#### SUBJECT: Comments on the Bay Delta Conservation Plan/California WaterFix Partially Recirculated Draft Environmental Impact Report/Supplemental Draft Environmental Impact Statement (RDEIR/SDEIS)

#### SUBJECT: Comments on the BDCP DEIR/DEIS

DATE:	July 17, 2014
то:	Reclamation District No. 830, Jersey Island
FROM:	Nate Hershey, Gary Kienlen, Patrick Ho, and Walter Bourez
SUBJECT:	Technical Comments on Bay-Delta Conservation Plan Modeling

Figure 4. Daily Flow in False River (~9,000 feet west of Webb Tract)

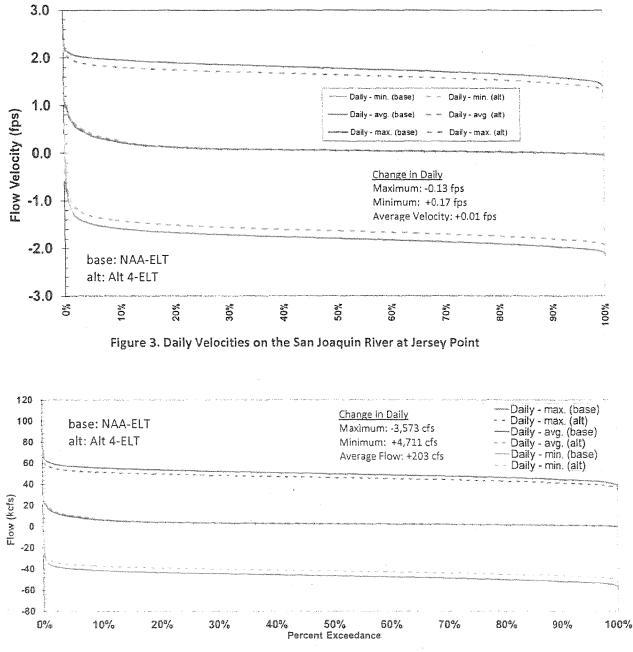
Dampening effects of the habitat restoration can be illustrated in river stage. When tides are allowed to disperse over a larger area which will be created by the habitat projects, stage in the Delta system will be reduced, as illustrated in Figure 2, Figure 5, and Figure 8. Daily maximum stage around Jersey Island is reduced under Alt 4 ELT by approximately 0.2 feet and daily minimum stage is increased by approximately 0.2 feet when compared to NAA ELT scenario. Daily maximum stage around Jersey Island is reduced under Alt 4 ELT by approximately 0.3 feet and daily minimum stage is increased by approximately 0.4 feet when compared to NAA ELT scenarios as illustrated in Figure 11, Figure 14, and Figure 17.
